DEPARTMENT OF THE NAVY
NAVAL FACILITIES ENGINEERING COMMAND – HAWAII
FORD ISLAND, PEARL HARBOR, HI
BUILDING 77
DISA-PAC FACILITY UPGRADES
OPS RACK ROOMS

AV-102

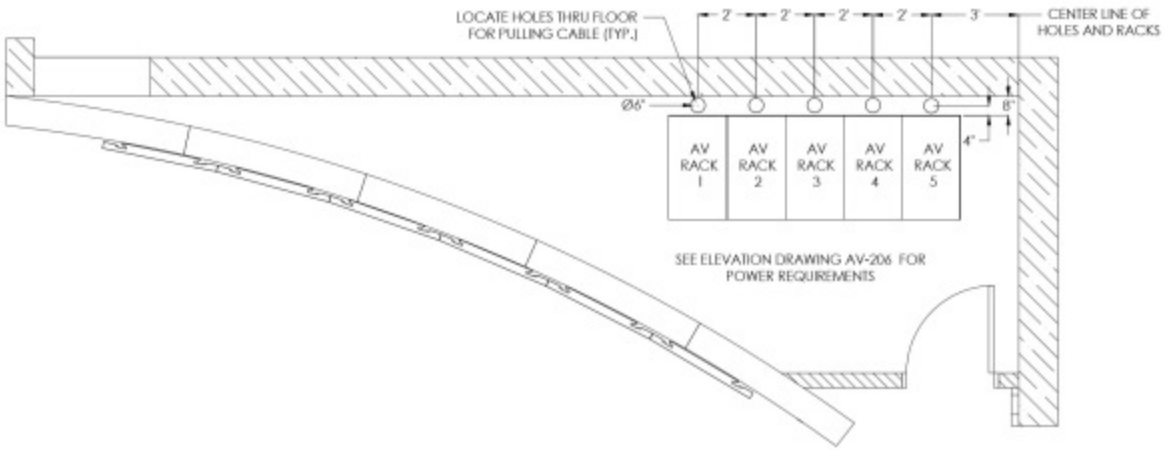
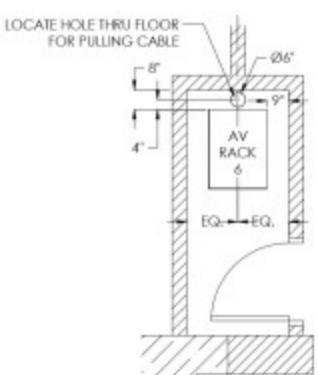
Note: AV racks shown will be replaced. 3 racks in the top section, and 1 rack in the bottom.
The new racks will be accessible from front and back.
